TITLE:  
ITEM NO:  
DESC.: PLAN, ELEVATIONS, DETAIL  
DESC.: CAFE PANTRY 3392

By: PD Scale: As Noted Job No. Dwg. No.  
Status: IN SUBMITTAL REVIEW Date: 2019-07-08 **02-01**

TITLE:	SECTIONS	Job No.	Dwg. No.
ITEM NO.:	CAFE PANTRY 3392	Scale: As Noted	02-04
DESC.:		Status: IN SUBMITTAL REVIEW	Date: 2019-07-08

H-02-04 VERTICAL SECTION  
SCALE: 1-1/2" = 1'-0"  
Arch't Ref.: NONE

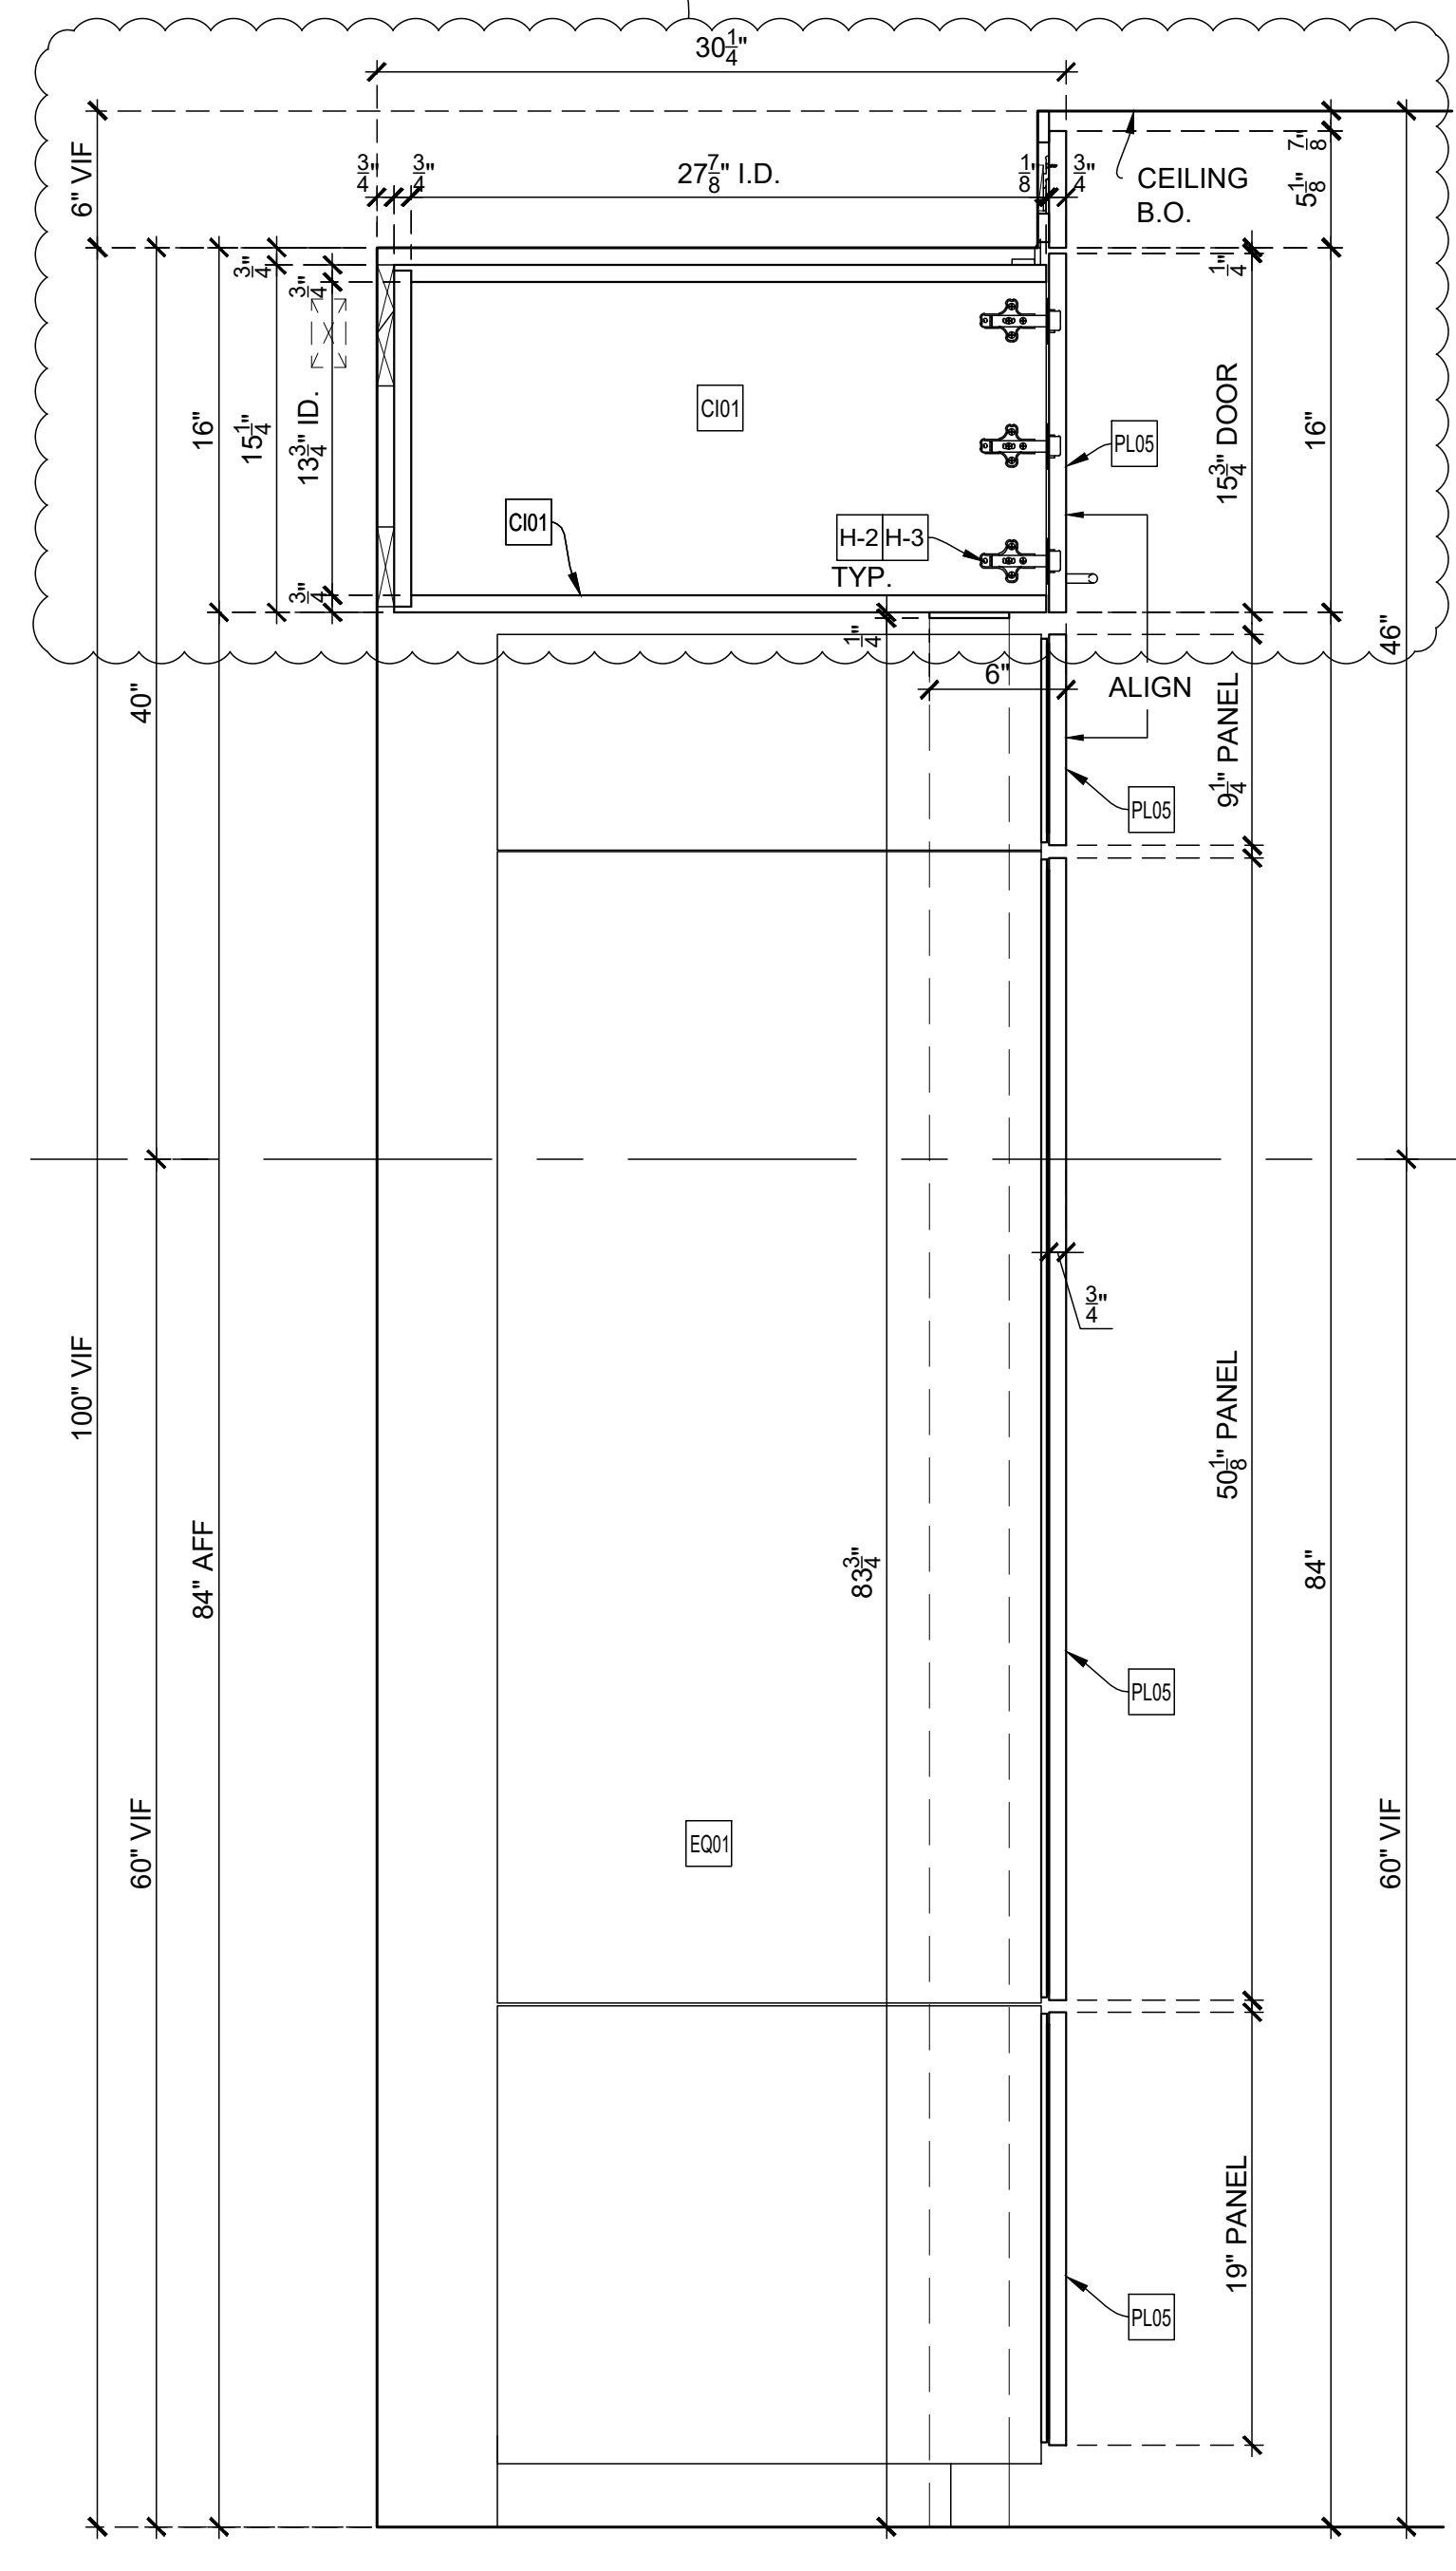
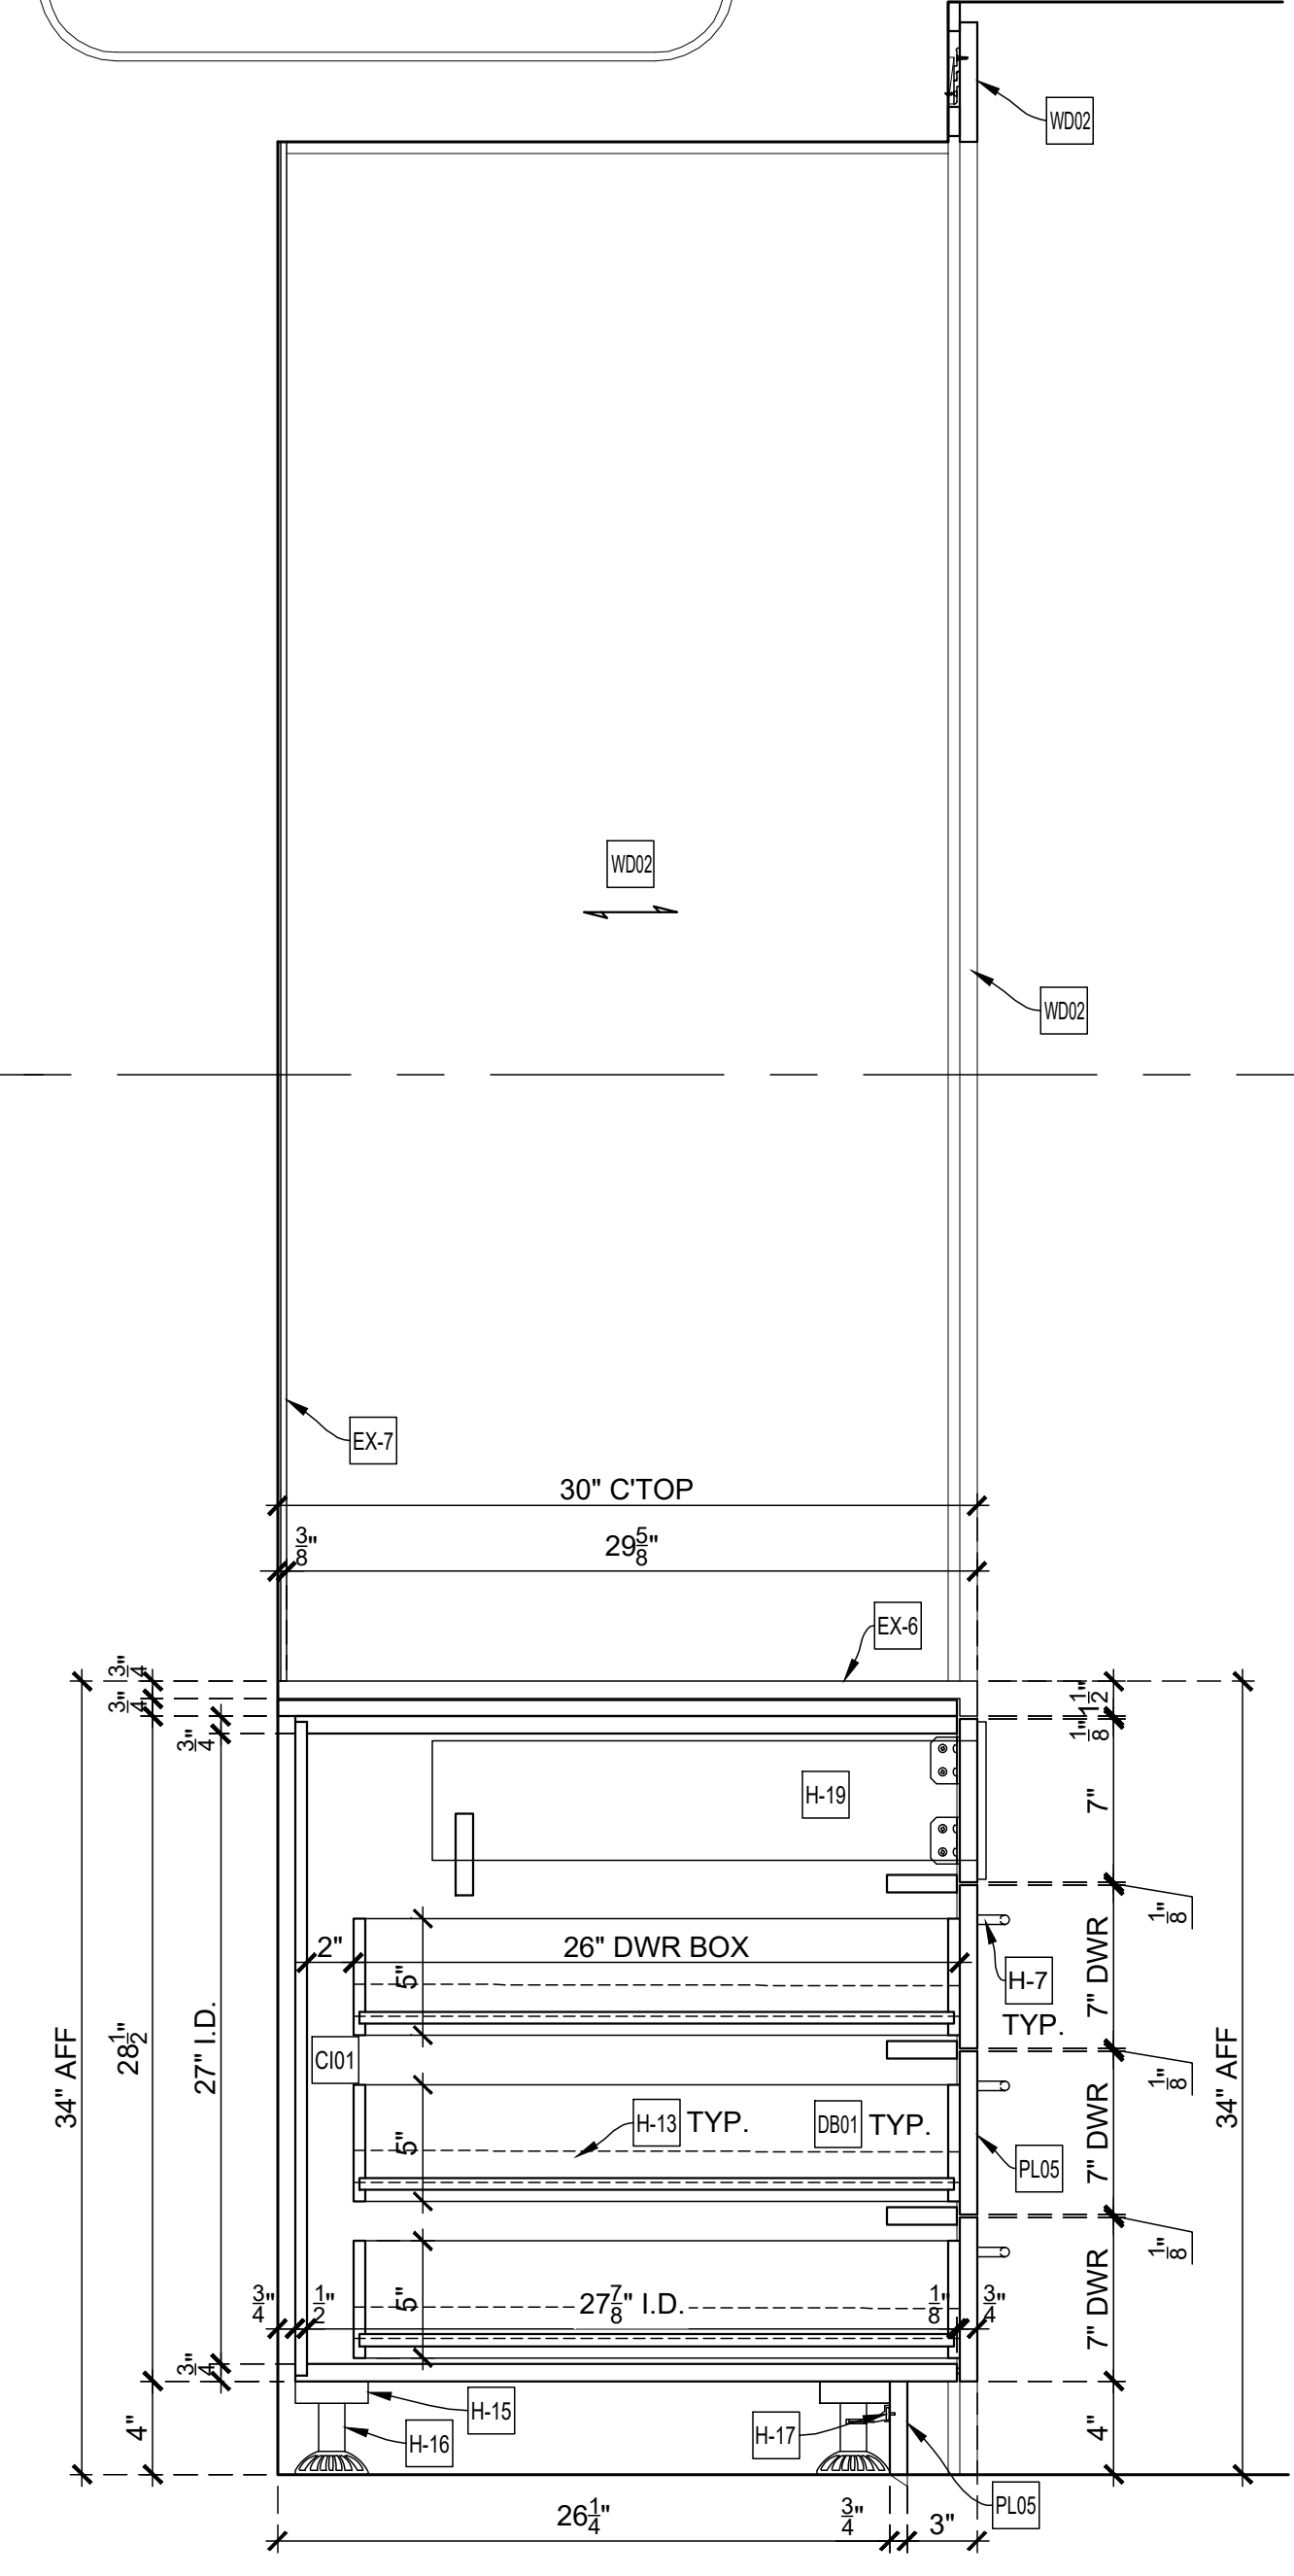
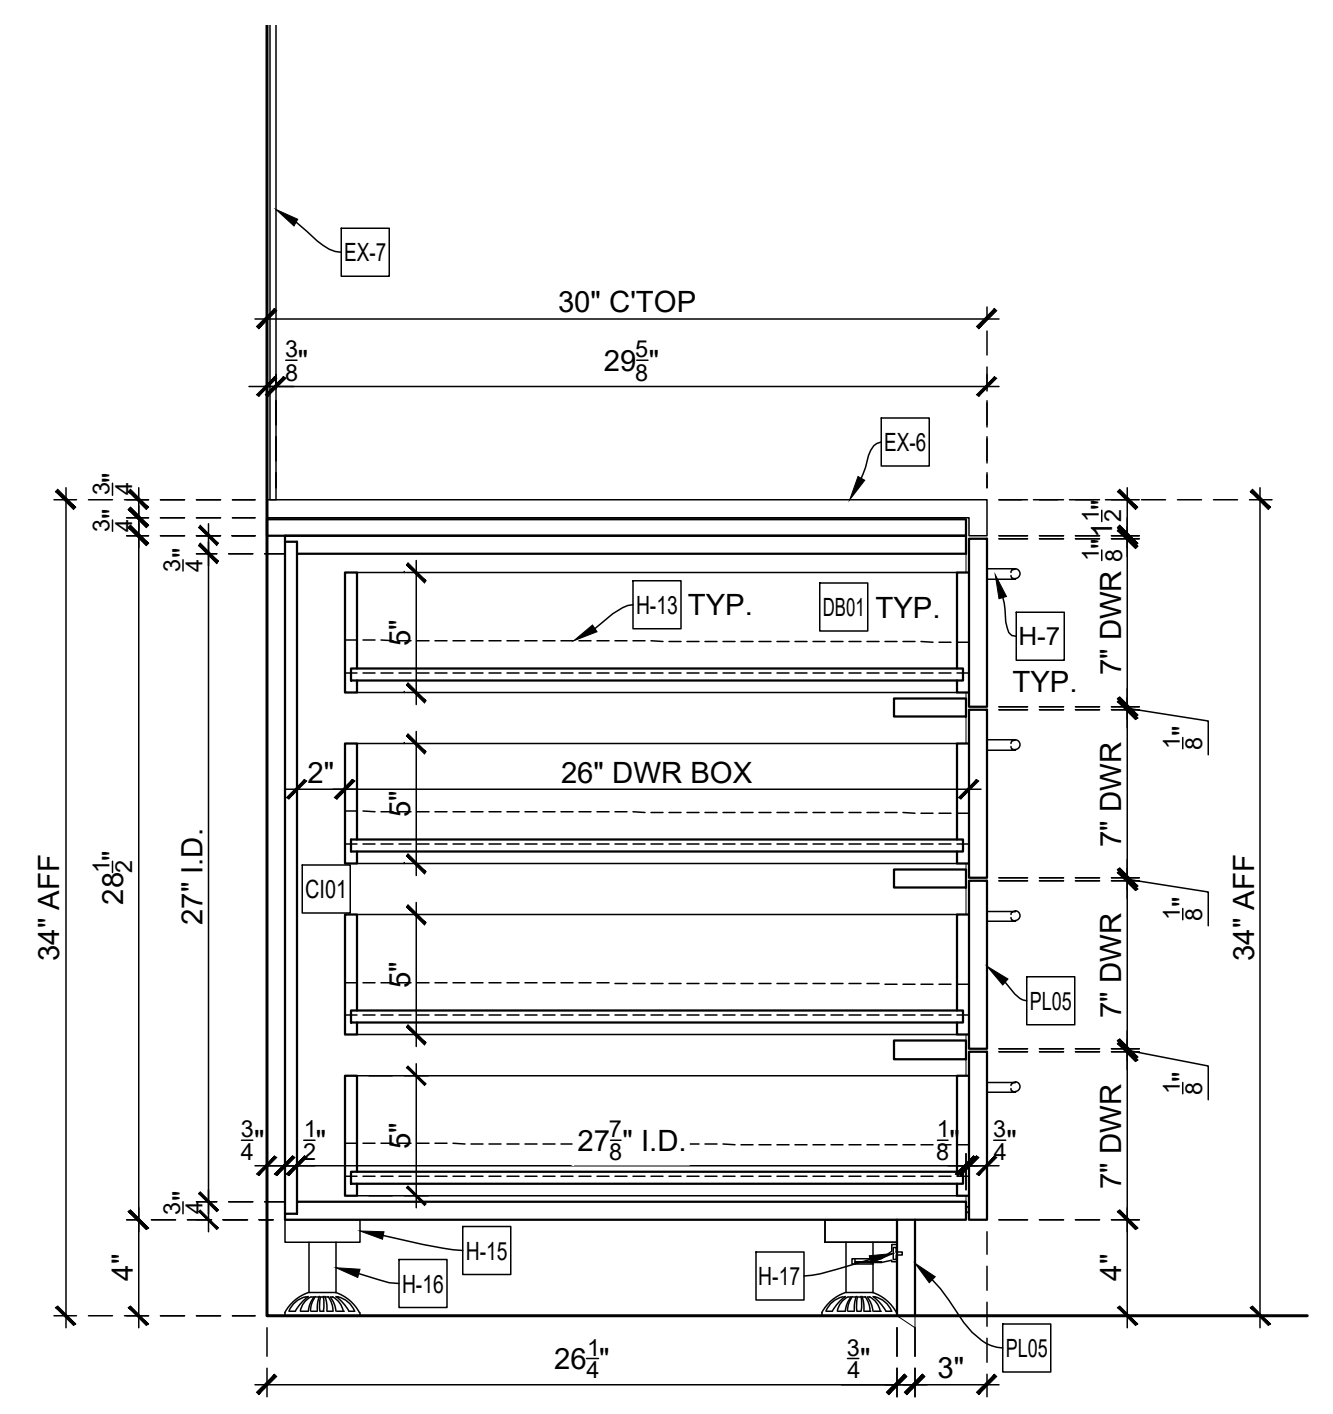
ARCHITECT NOTE:  
PLEASE VERIFY USE OF CABINET WITH DOOR  
INSTEAD OF FIXED PANEL ABOVE REFRIGERATOR

ARCHITECT NOTE:  
PLEASE VERIFY ALL WOOD  
GRAIN DIRECTIONS.

PLEASE VERIFY ALL WOOD GRAIN DIRECTIONS.  
 PLEASE VERIFY SECTION DUE TO LACK OF DETAILS ON ARCHITECTURAL DRAWINGS.

ARCHITECT NOTE:  
PLEASE VERIFY SECTION DUE  
TO LACK OF DETAILS ON  
ARCHITECTURAL DRAWINGS.
